10 March 2022  
Ref 20417

**SSD-15882721**  
**PROPOSED MIXED USE DEVELOPMENT**  
**LOT 55 DP 1253217 – DORAN DRIVE PLAZA PRECINCT**  
**VEHICULAR ACCESS, ON-SITE LOADING & WASTE COLLECTION MATTERS**

I refer to your letter dated 14 September 2021 requesting additional information in respect to the abovementioned development proposal (SSD-15882721). The following advice is provided in respect of the matters raised under the ‘*Internal Traffic and circulation comments*’ – *Item 3* and ‘*Asset Management, Traffic and Parks*’ sections of your letter.

Drawing Title  
Ramp Sections  
Ramps 1&2,4&5

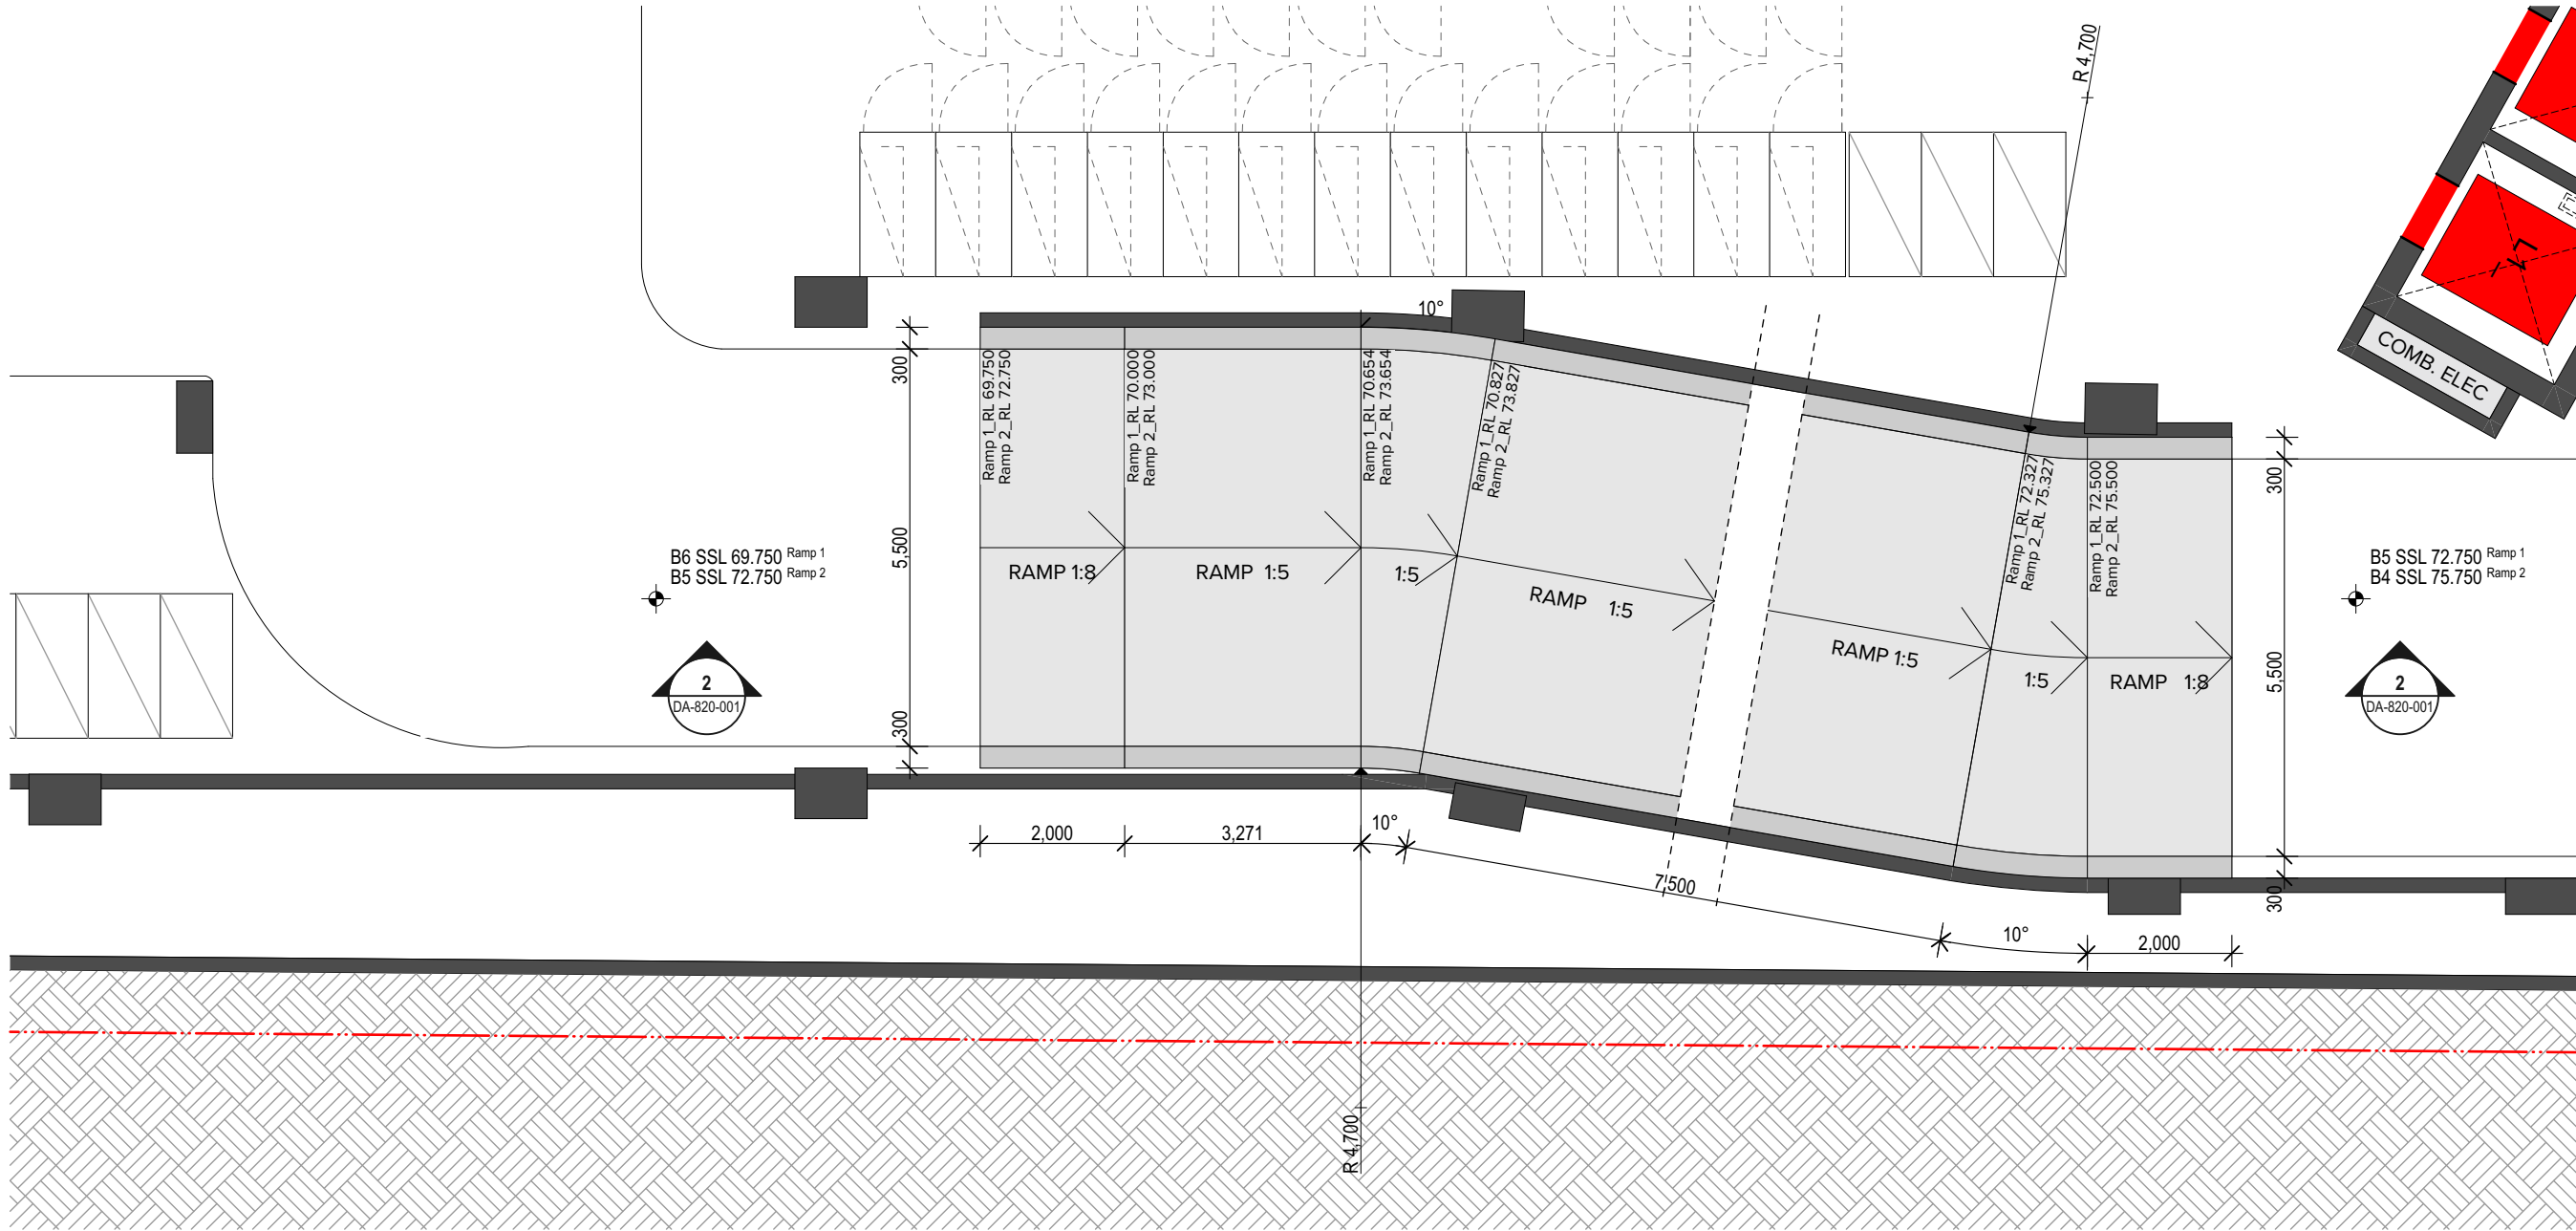
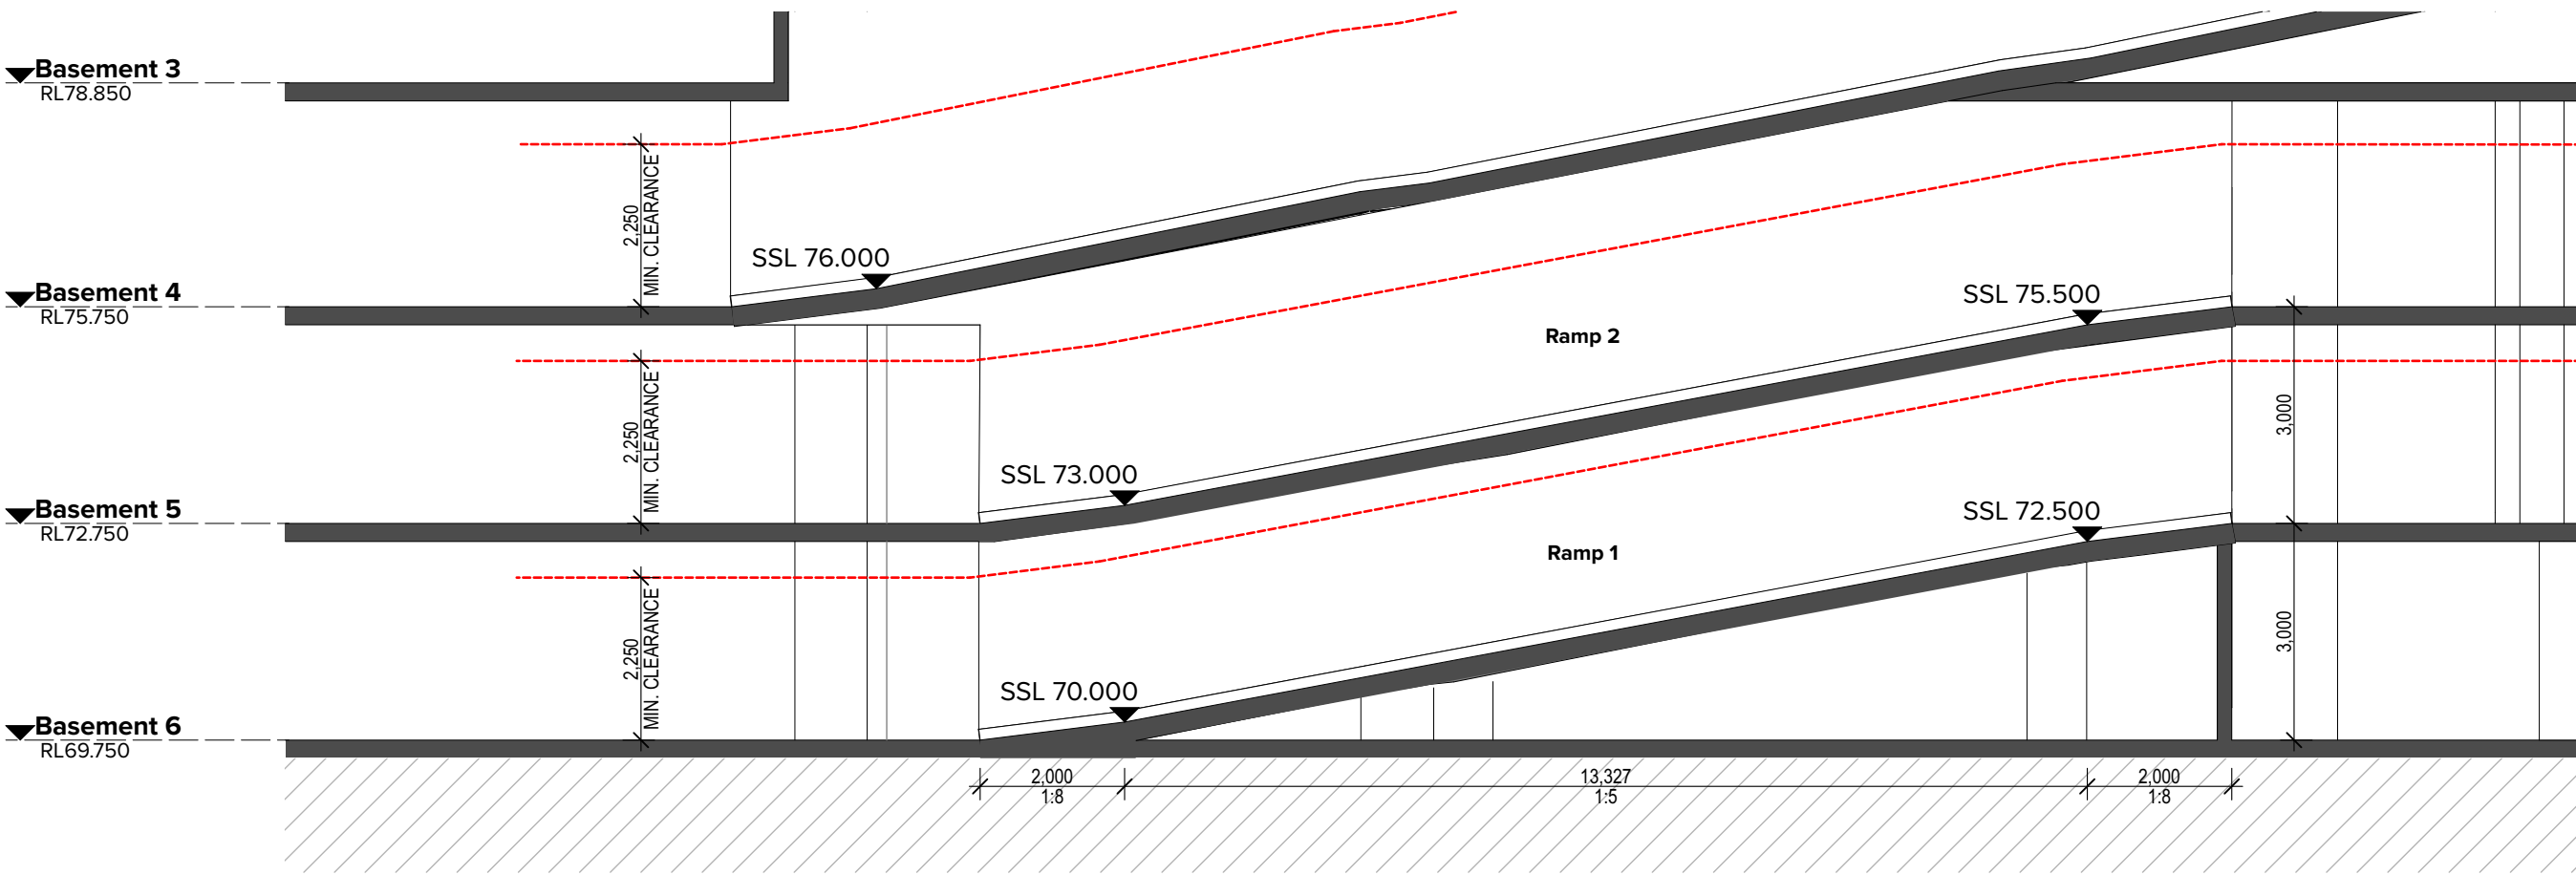
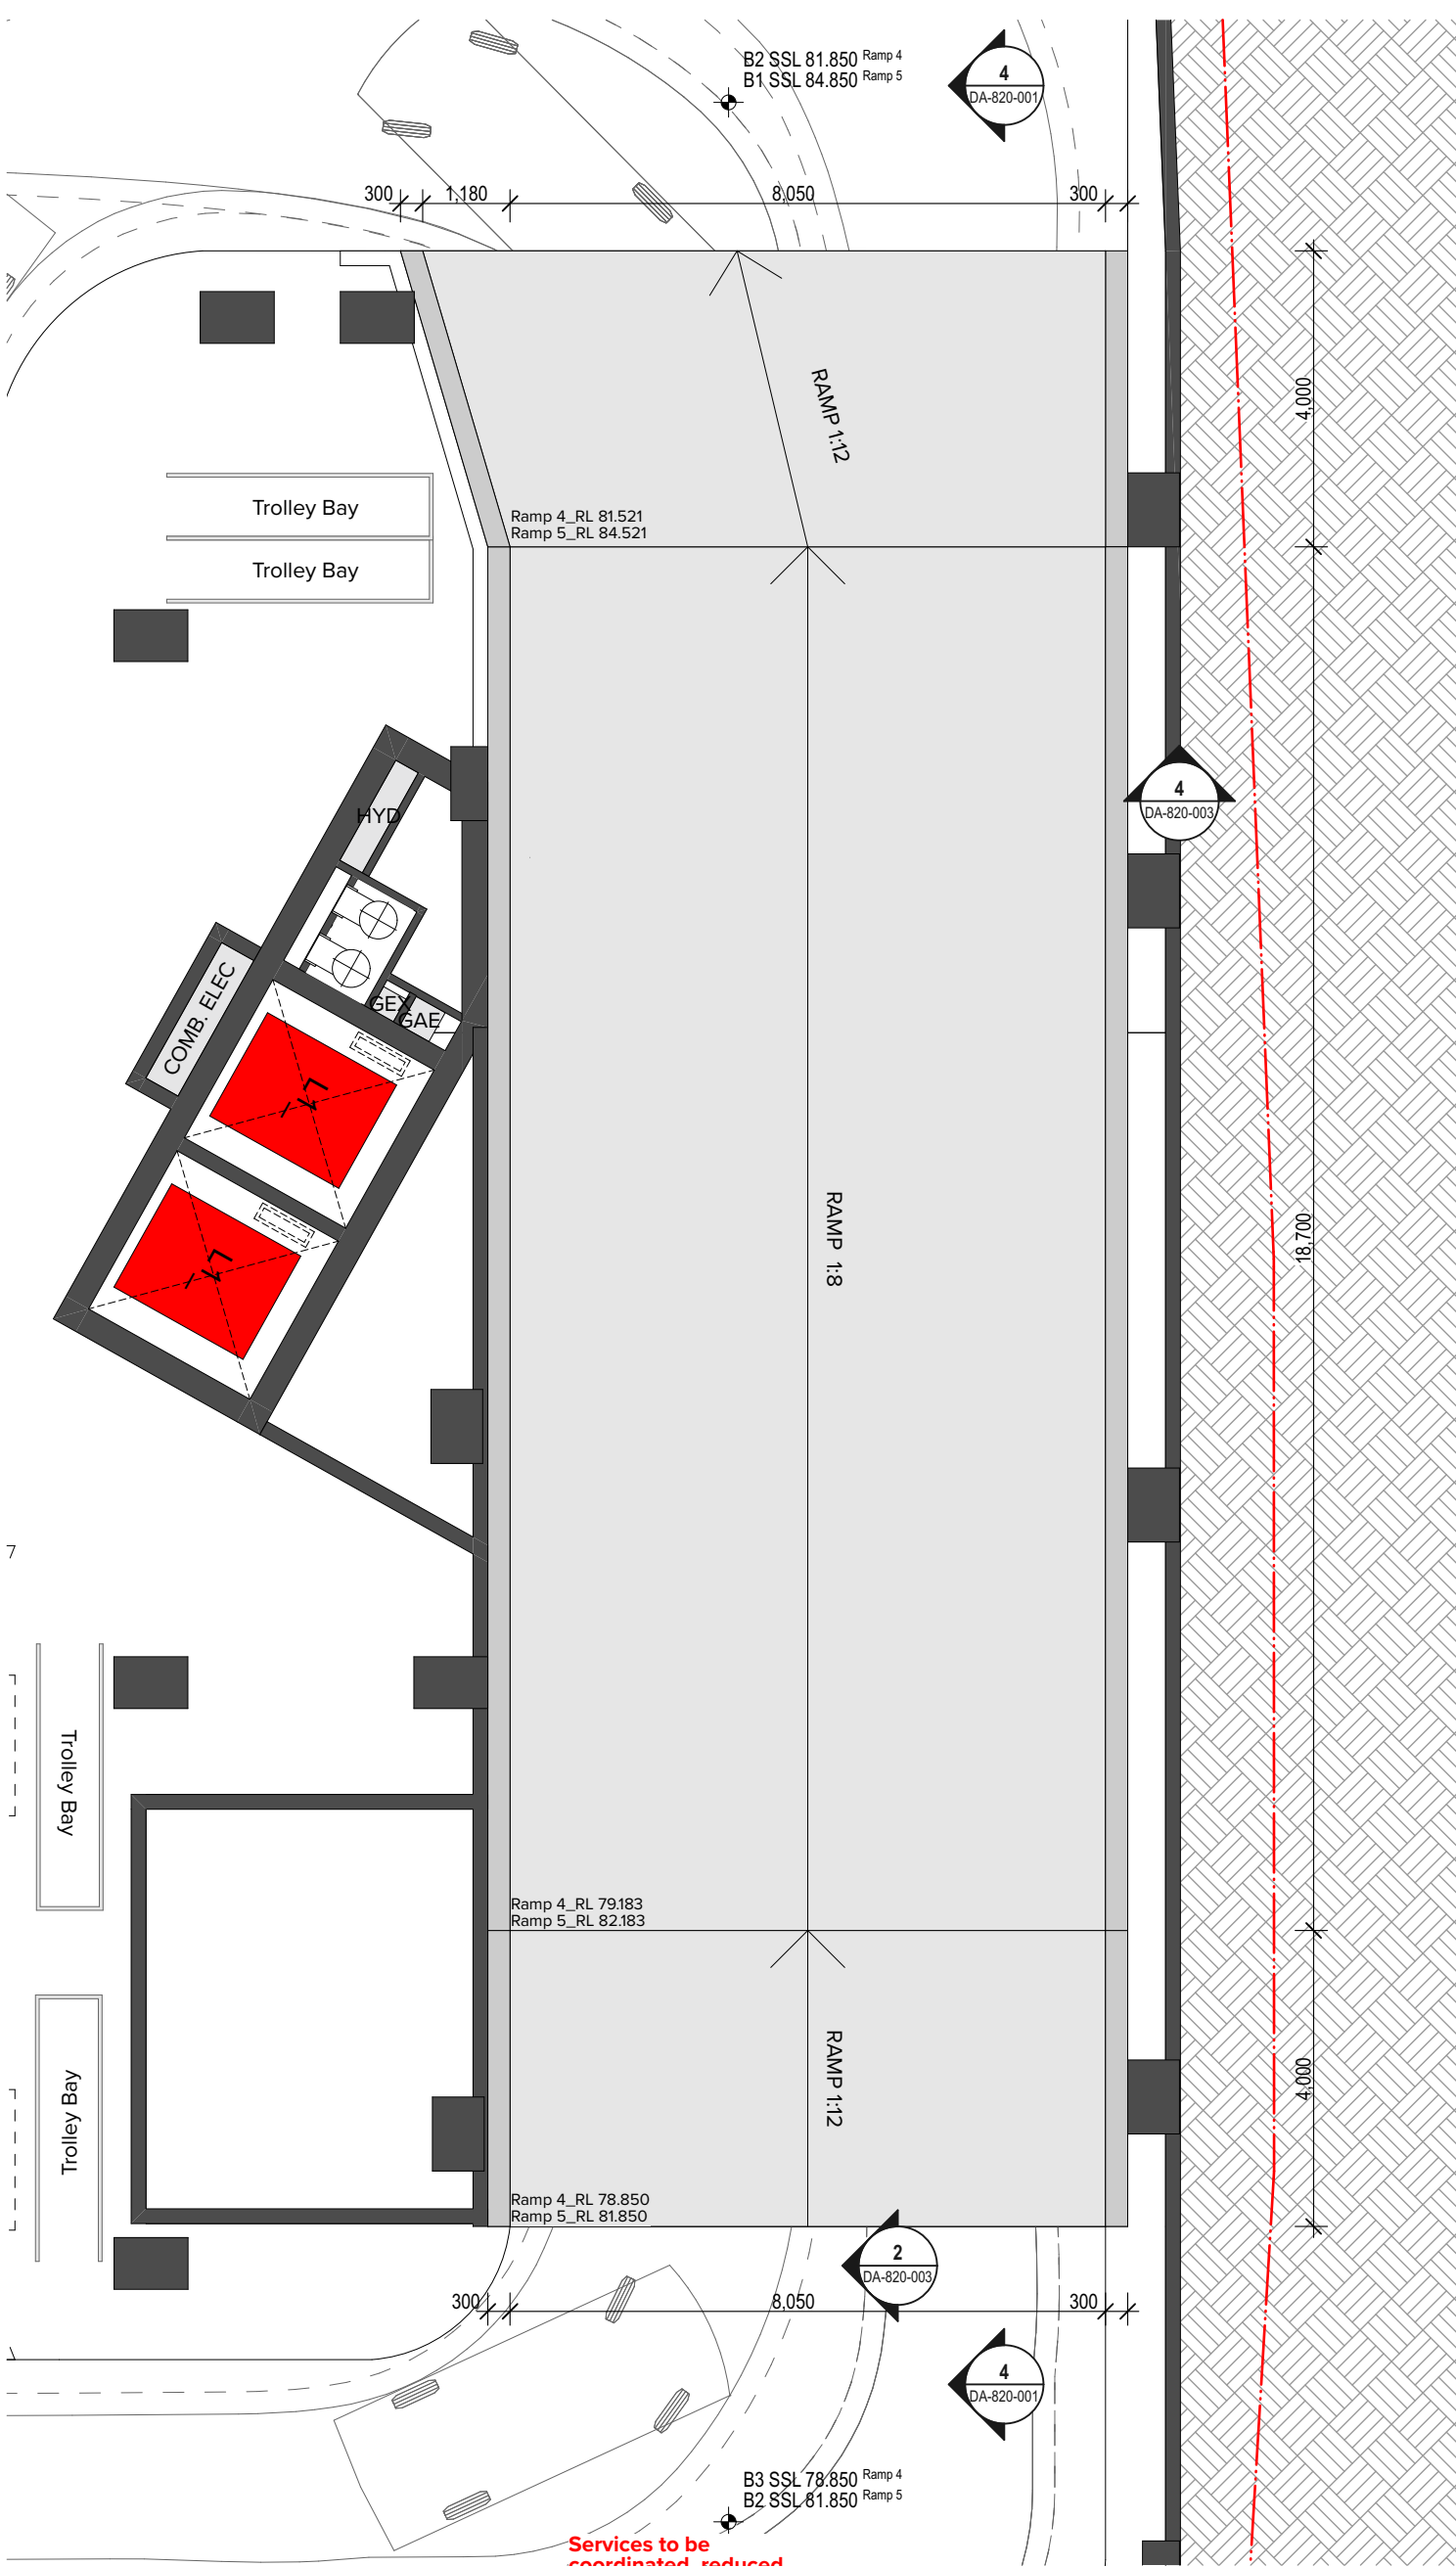
*“3.3. A cross section plan of driveways and ramps will need to be provided on plan; it must detail compliance gradient and changes of grade with the relevant AS/NZS 2890.1 and AS2890.2.”*

As requested, detailed cross section plans of the proposed basement access driveways and ramps have been provided and are attached. I can also confirm that the proposed ramp gradients and transition lengths comply with the relevant aspects of AS2890.1:2004. In particular it is noted that the ramp has been restricted with a maximum 1 in 5 (20%) grades, separated by 1 in 8 (12.5%) transitions, or less, in accordance with AS2890.1 requirements.
